# 1992 Corvette: Service Bulletin: Hood Latch Striker Bolt

**Subject:** HOOD LATCH STRIKER BOLT (USE PAST MODEL SERVICE PARTS)

**Model and Year:** 1992 Corvettes, Prior to VIN Breakpoint N5100919

**Bulletin Number:** 92-43-10 - (11/07/1991)

VIEW A

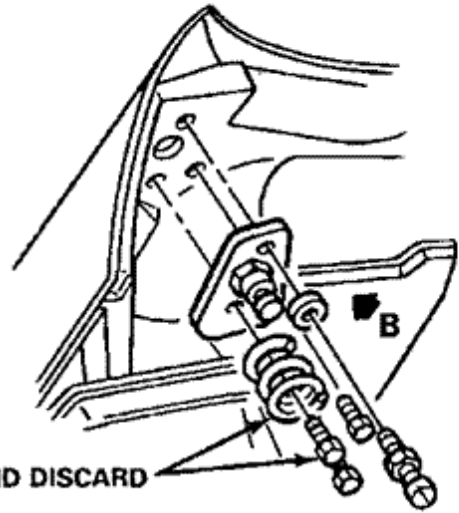
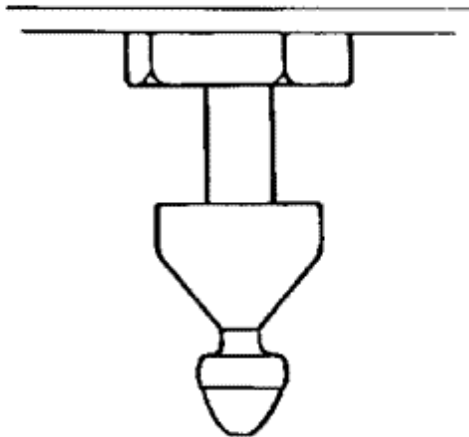
1. Raise hood to full open position. 2. Remove pop up spring and attaching bolt from bracket and discard (see View A). 3. Install new attaching bolt in position, tighten and torque to 27 N.m (20 lbs. ft.). 4. Loosen the locking nut on the striker latch bolt, remove bolt and nut from hood bracket, disassemble nut from bolt and save the nut for use on the new striker bolt. **DISCARD THE ORIGINAL STRIKER BOLT.** 5. Preassemble the new bolt, retainer, spring and original lock nut (see View B).

VIEW B — PRODUCTION

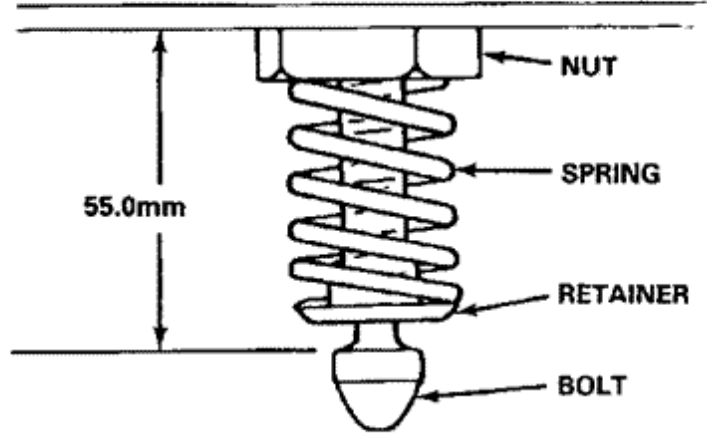
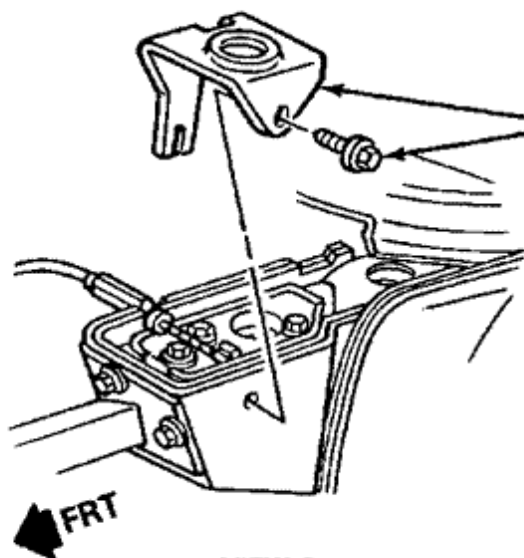
**NOTE:** The nut has a cavity on one side to act as spring seat.

6. Install the new striker bolt assembly to the bracket on hood, set initial

height as indicated on the illustration and tighten the locking nut. 7. Remove the outer attaching bolt for the spring seat (View C), loosen the inner attaching bolt and remove and discard the spring seat and outer attaching bolt. 8. Tighten the inner attaching bolt and torque to 25 N.m (18 lbs. ft.), see View C, inside View. 9. Carefully lower hood, check for latching and flushness conditions and adjust as required.
